MEMORANDUM

**Subject: Review of Contaminant Conditions
CSXT Bramlette Road Former Manufactured Gas Plant (MGP)
Greenville, South Carolina
Project No.: 019-12**

Date: 10/11/2019 Project #: 019-12 **Figure 3**

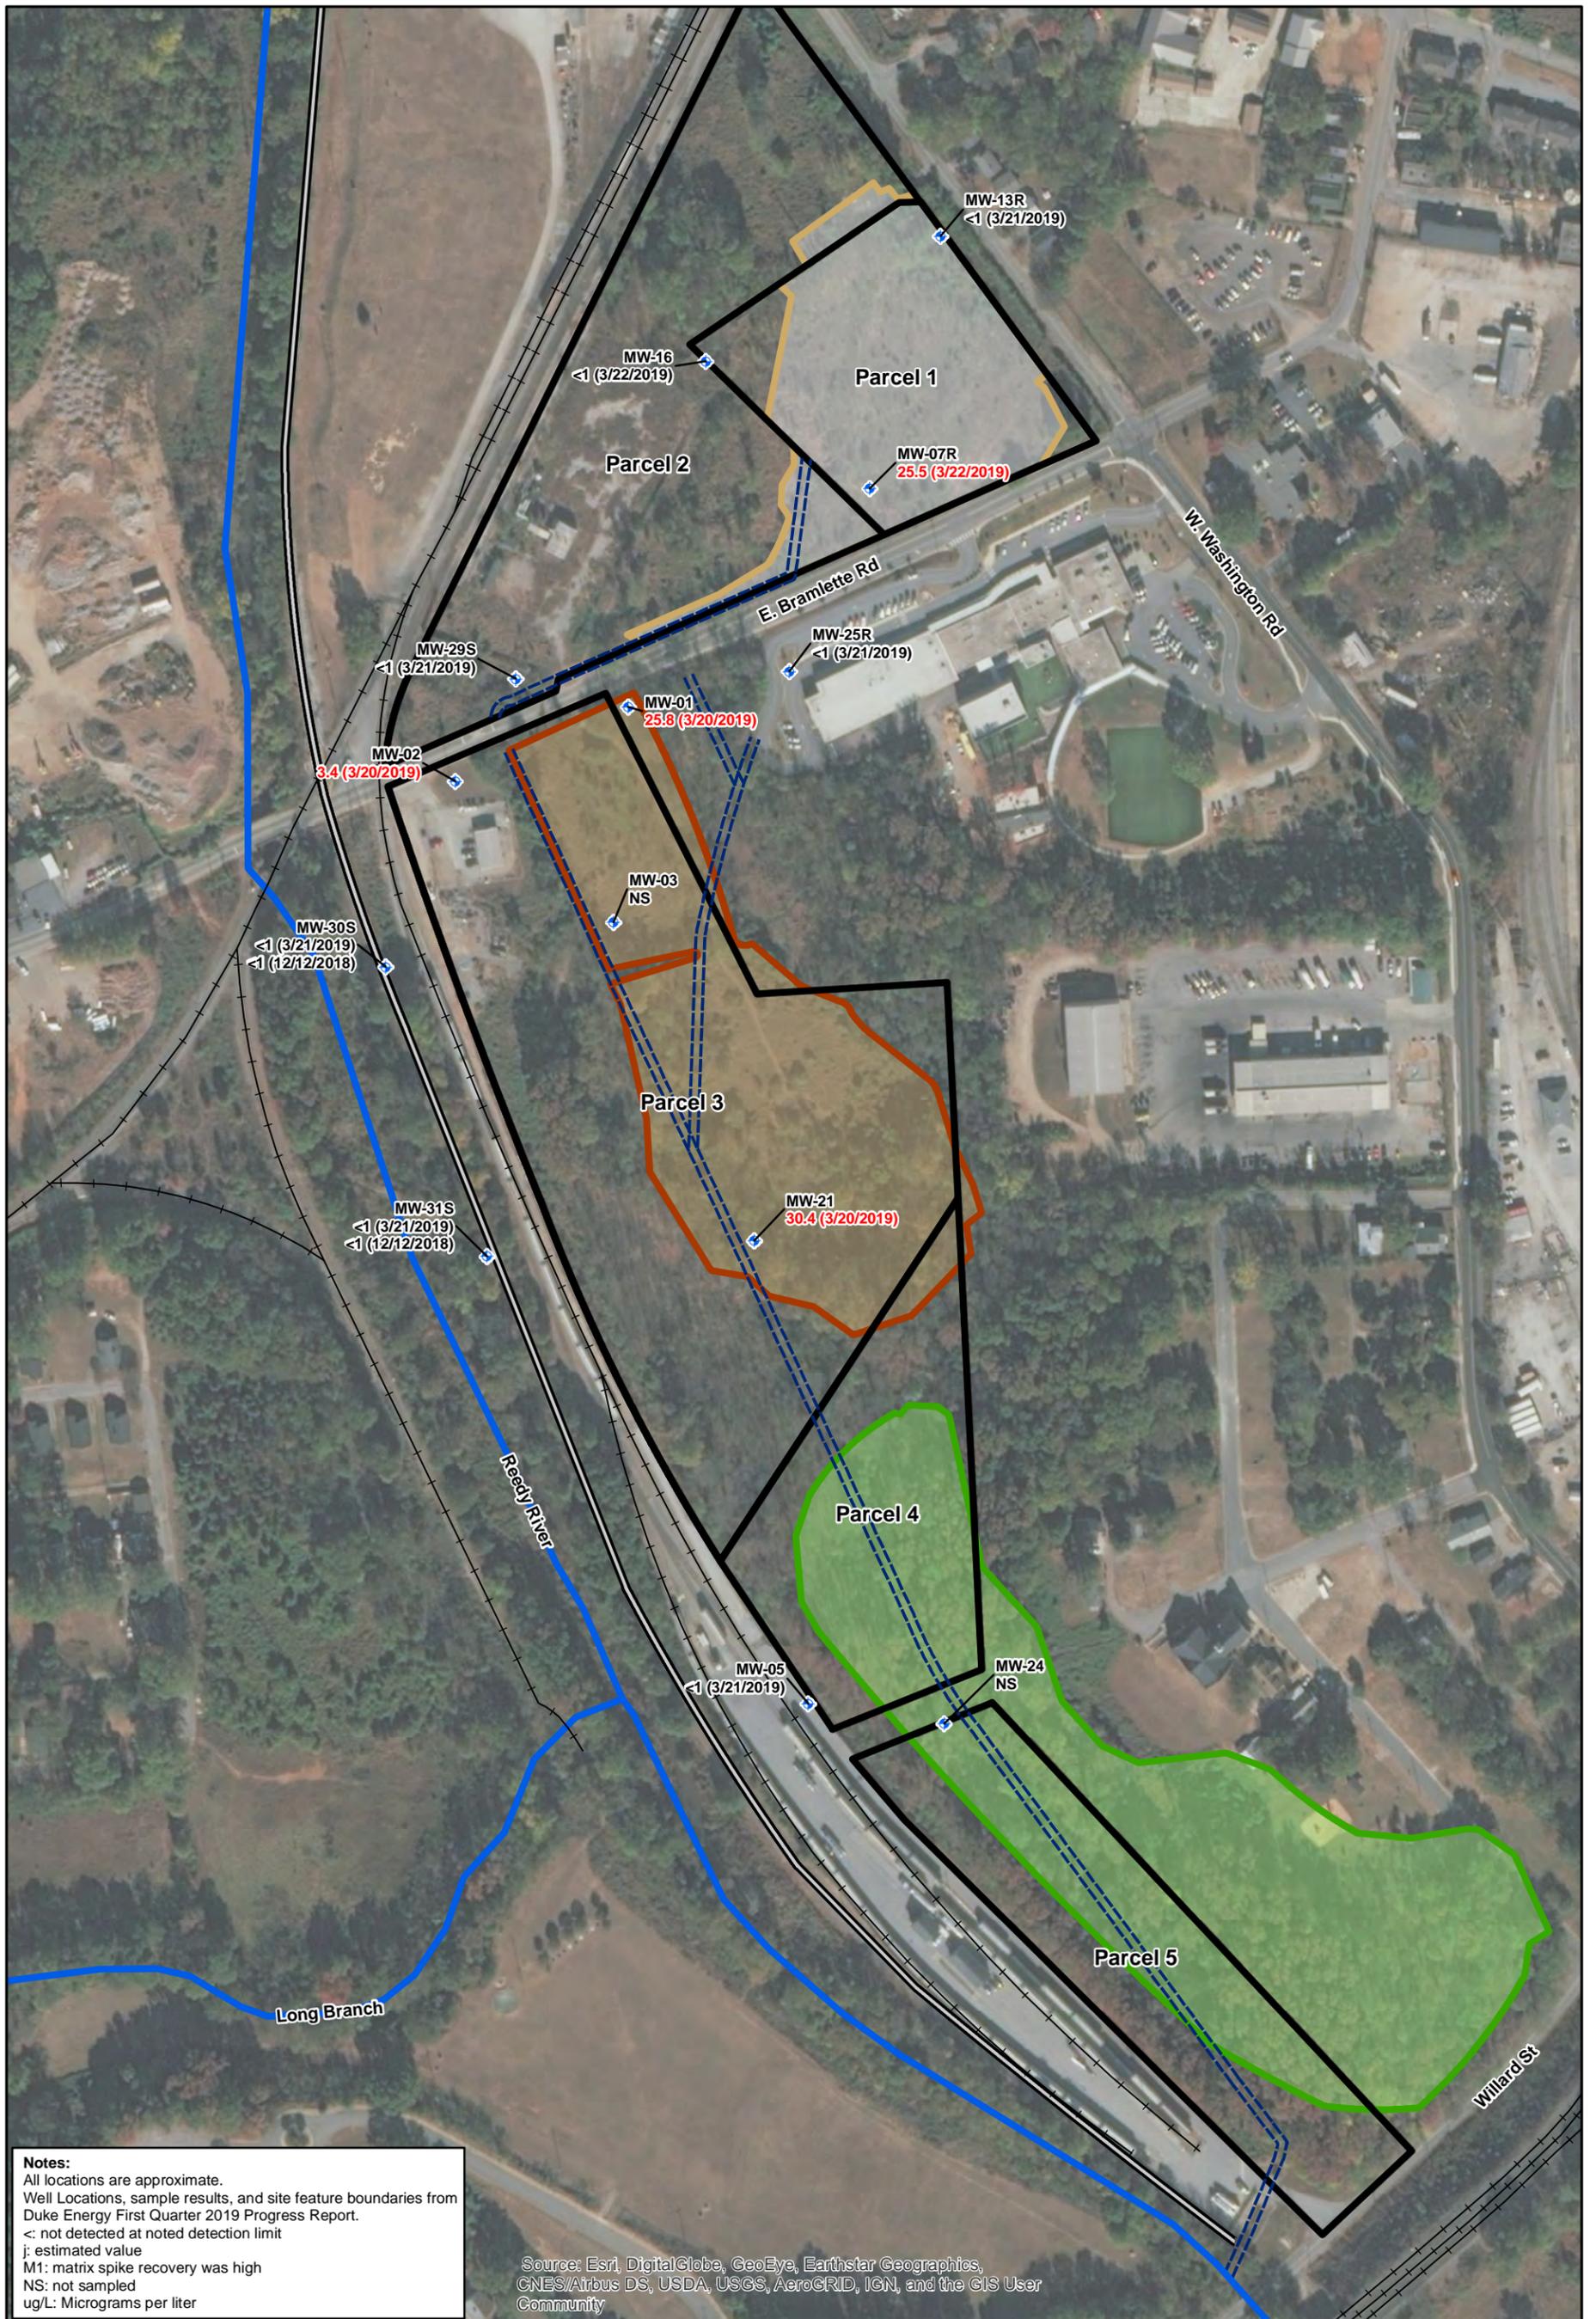
The groundwater flow direction at the Site is west-southwestward; that is, towards the Reedy River (**Figure 3**). A plume of groundwater contamination extends from the southwest corner of the former MGP at least 750 feet in the down-gradient (south-southwest) direction, and 850 feet wide laterally. In March 2019, groundwater was sampled from a newly installed monitoring well (MW-29TZ) approximately 500 feet down-gradient of the former MGP. Benzene and naphthalene were detected in this sample at concentrations of 1,920 ug/L and 4,060 ug/L, respectively. The MCL for benzene is 5 ug/L, and the risk-based screening level (RBSL) for naphthalene is 25 ug/L.

The groundwater flow direction within the shallow aquifer at the Site is southwestwards to west-southwestwards (AES, 1996; Duke Engineering & Services, 2000a; S&ME, 2016; ERM, 2018b; Duke Energy, 2019b) (**Figure 3**).
